**RFB-2022-42**  
**SCCC CHEMISTRY LAB RENOVATION**

**ADDENDUM #2**

Issued Date 3/2/2022

Chem Lab 202 Cabinet Details

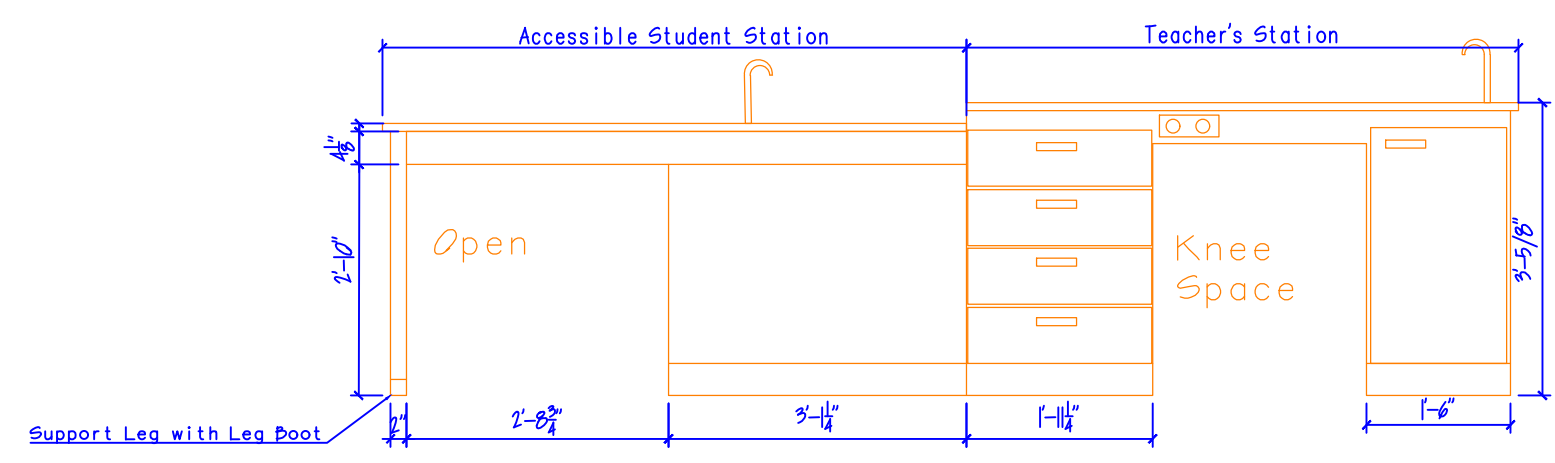
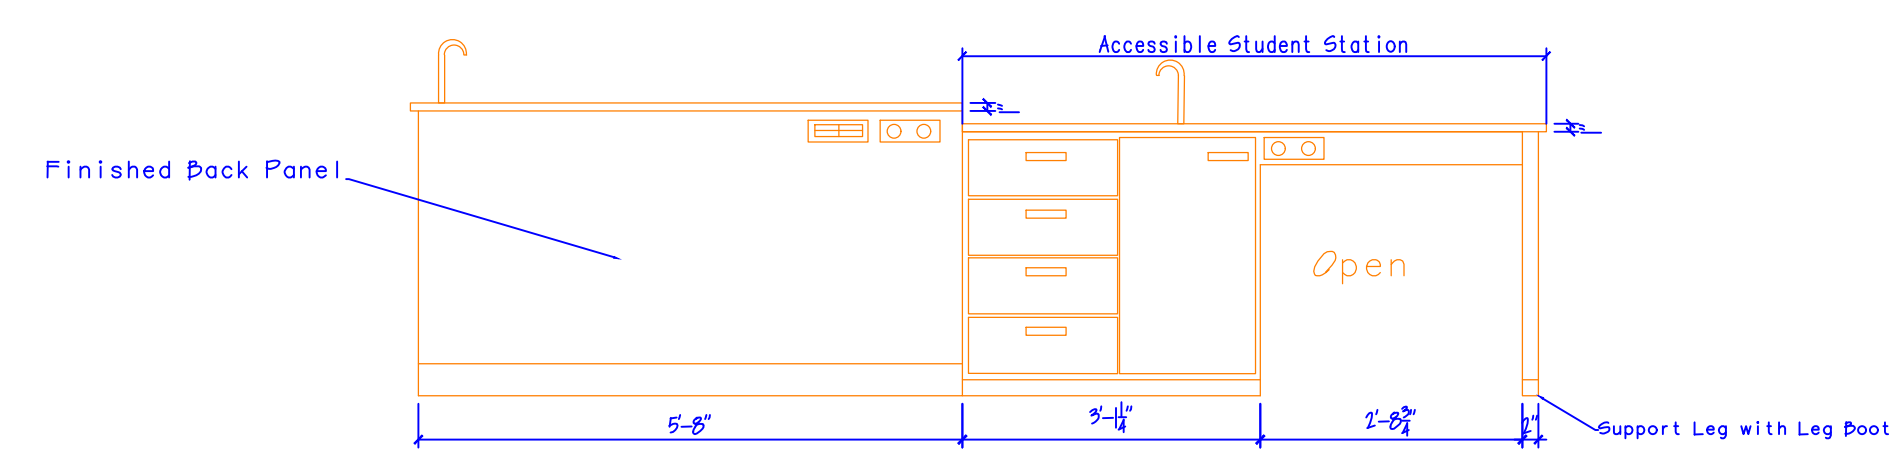
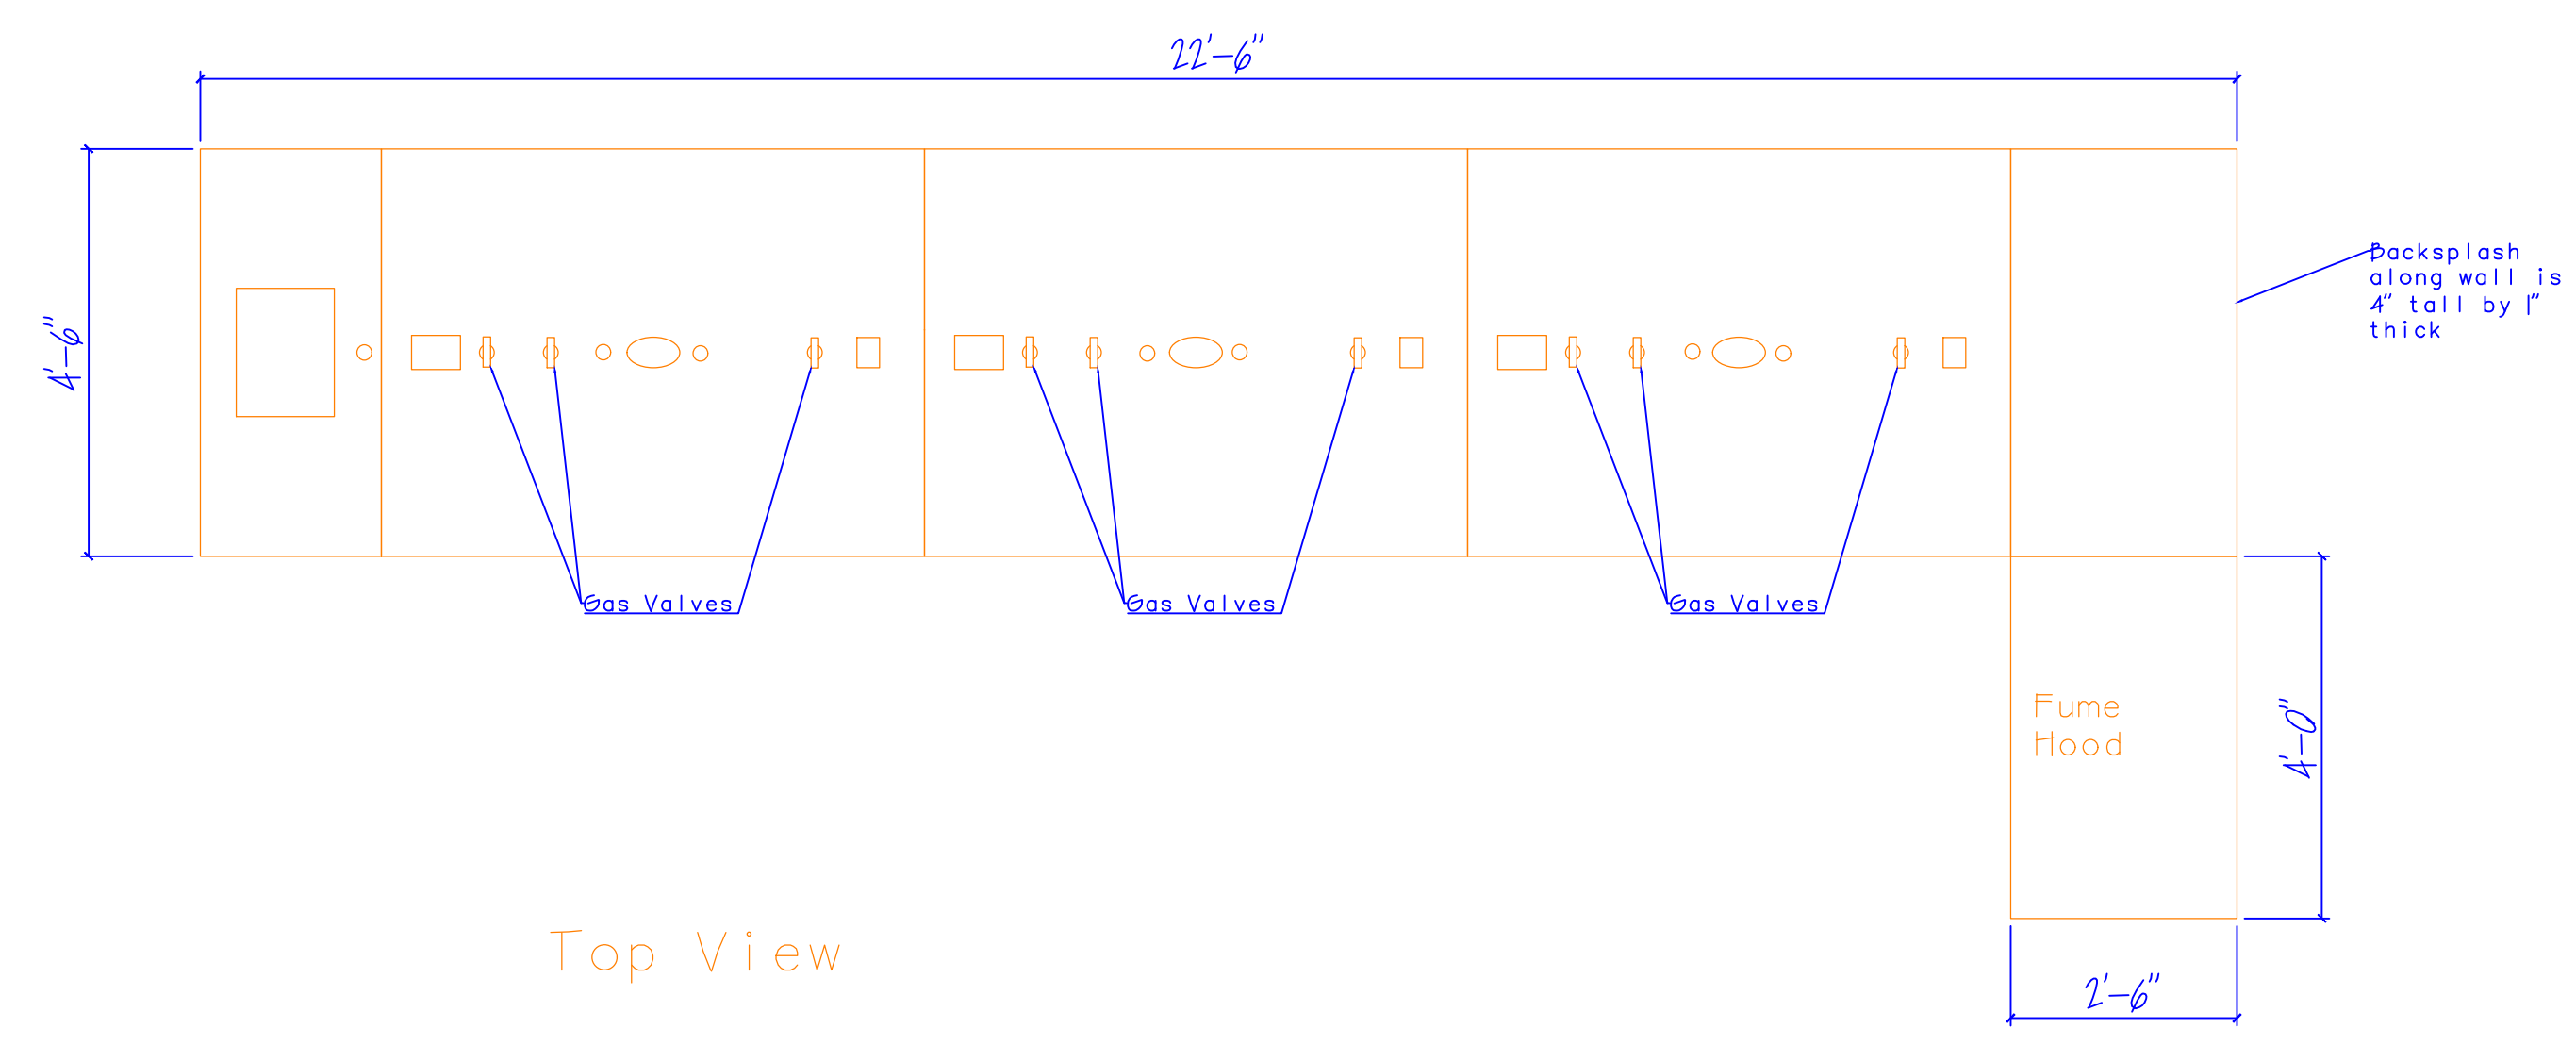
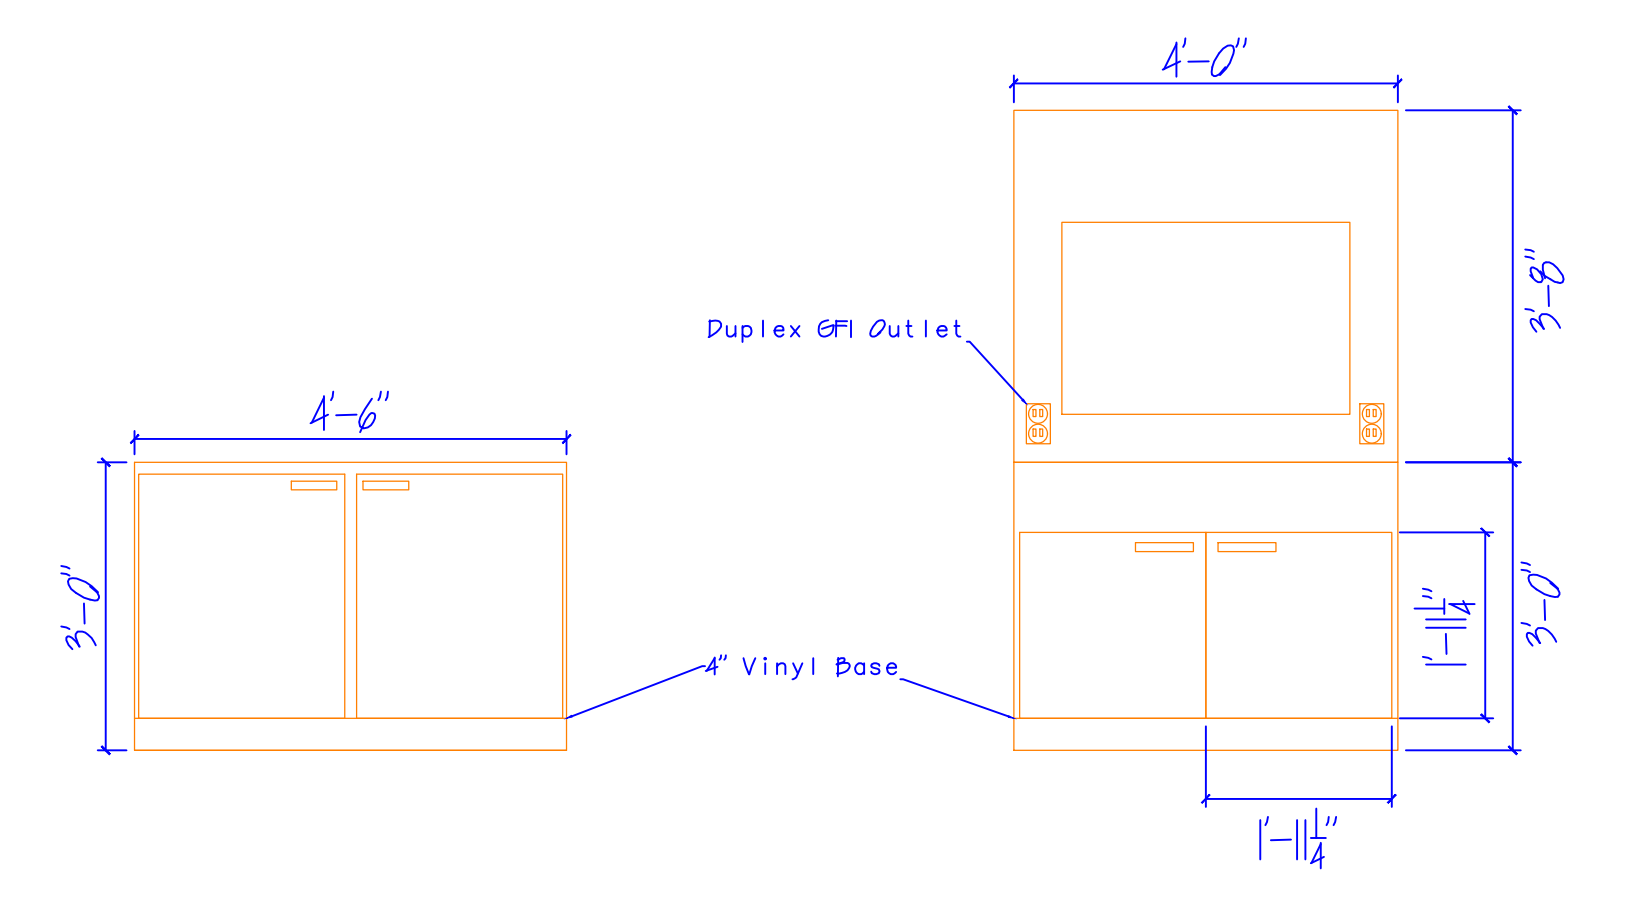
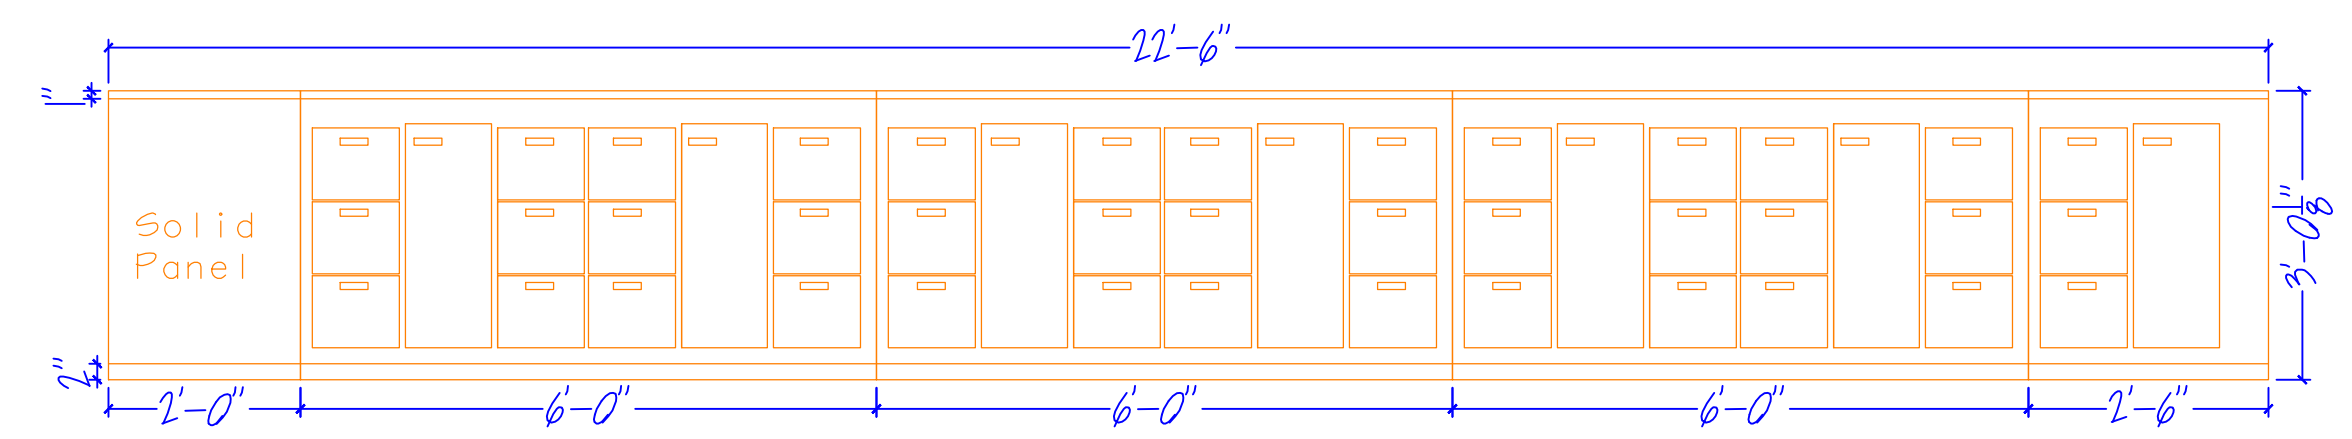
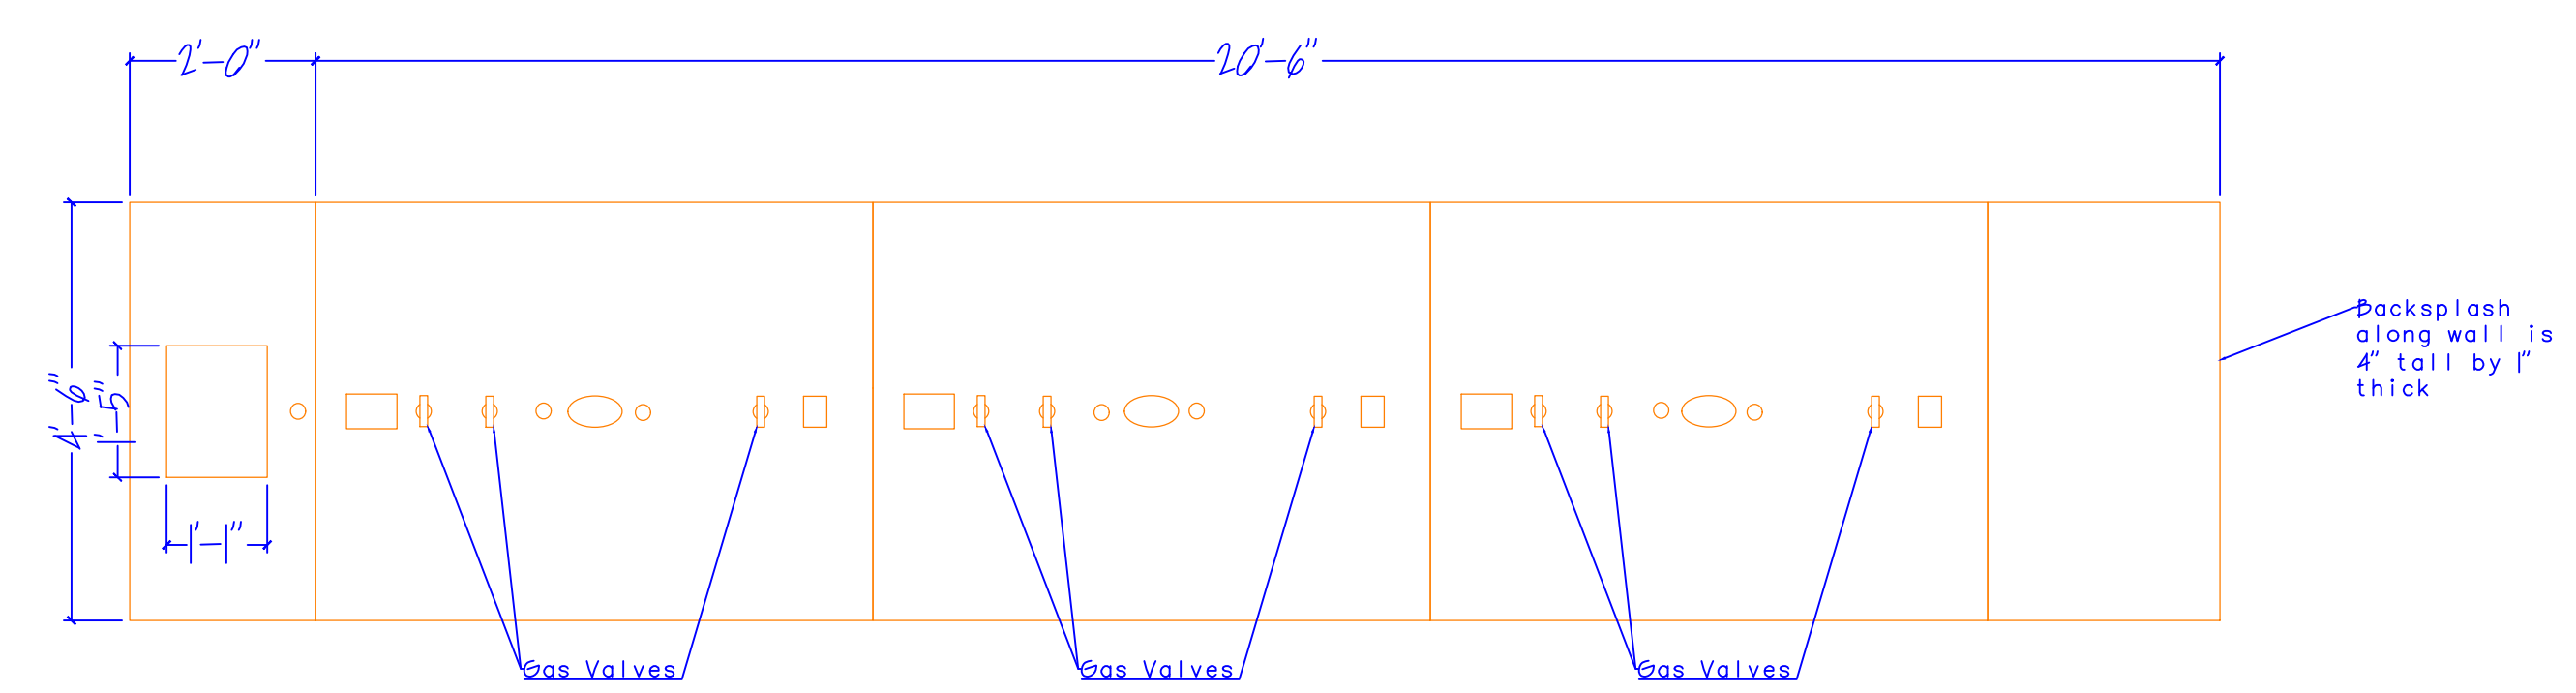
1. Areas to quote in Chem Lab 202: Bench #1, Bench #2, and Teacher Station, were identified in the A-2 Cabinet Details and Existing Condition Images, however it appears a Bench #3A & Bench 3B, on left & right sides of the 2 Fume Hoods on the back wall may not have been identified as well as a Bench #4 at the end of Bench #1. Please outline those pieces as well as anything else that needs to be included in the bid for room Chem Lab 202.

- 
5. We see gas valves and outlets in the existing photos on the epoxy worksurfaces of the Benches, but there are no dimensions on the plans where they need to be – can these dimensions be provided?

Answer: [Please see revised drawings attached to this addenda.](#)
  9. A-2 Cabinet details is a 1 of 1 drawing showing the elevations and dimension of “cabinet typicals” for Prep Room and Instructors Accessible Station Cabinets. No cabinet typical details were provided for Chem Lab Room 202, Chem Lab-A-1 is an additional drawing (1 of 1) provided, but only provides an overhead view of the Chem Lab Room 202 bench dimensions. Can a drawing be provided of what is needed for an actual “cabinet typicals” requested for Chem Lab 202?

Answer: [Please see revised drawings attached to this addenda.](#)

Answer: [Please see revised drawings attached to this addenda.](#)
  6. Based on the illustrations in A-2 Cabinet details for “Prep Room” Cabinets and the illustrations in Chem Lab A-1 details for “Instrument Room”, are Prep Room & Instrument Room the same rooms?

Answer: [Please see revised drawings attached to this addenda.](#)
  10. One ADA compliant cabinet is depicted in Chem Lab 202, no ADA compliant cabinets are shown or requested for Prep Room Cabinetry. Is there a need for an ADA compliant cabinet in the Prep Room cabinetry?
